**Final Report  
Project Summary and Permit Review  
'39 Ventures Aggregate Recycling Facility  
Verdi, Nevada**

**June 19, 2015**

Prepared For:  
The Verdi Community Council Inc.

Prepared by:  
McGinnis and Associates, LLC  
65 Regency Way Suite C  
Reno, Nevada 89509  
P: 775-853-0449

Figure 1. Zoning map provided by 39 Ventures. The lot is zoned community commercial with nearby public facility, open space and large-lot residential.

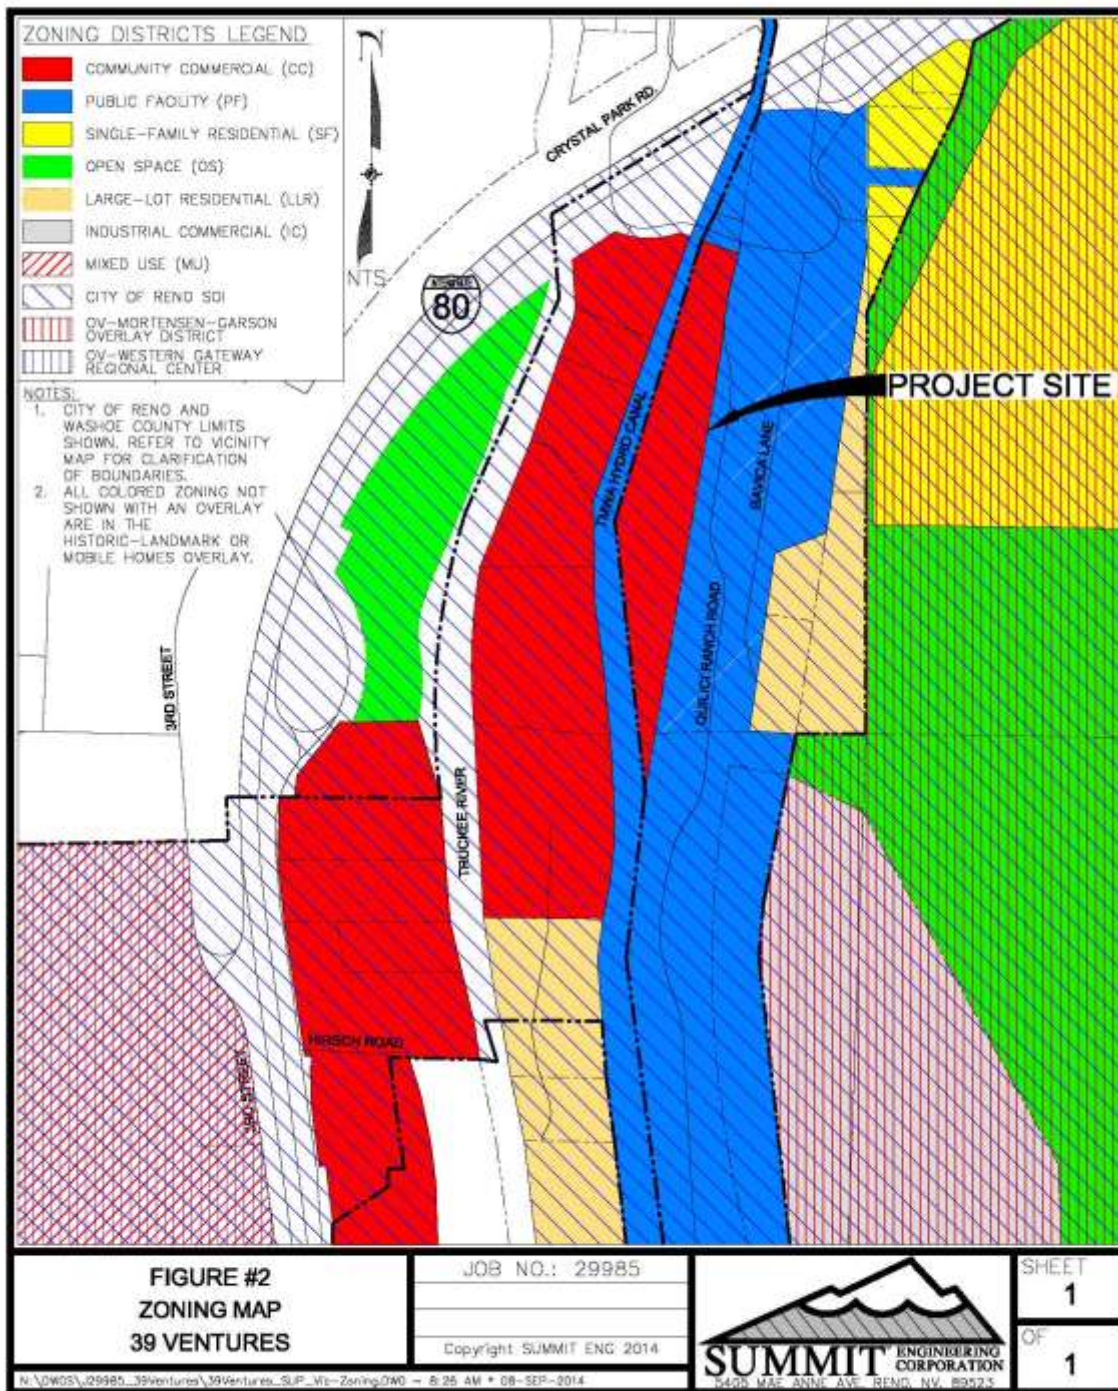
A zoning map provided by 39 Ventures for this report is included here as Figure 1. The 39 Ventures lot and those across the river have been represented in some discussions as zoned Industrial (personal communication, Ryan Kaultz, April 17, 2015) but is actually zoned Community Commercial, not Industrial, requiring the Special Use Permit discussed below. According to local residents, there is an effort to maintain the general area for a larger greenbelt following the Truckee River to provide recreational opportunities and preserve river and riparian habitat from incompatible development.
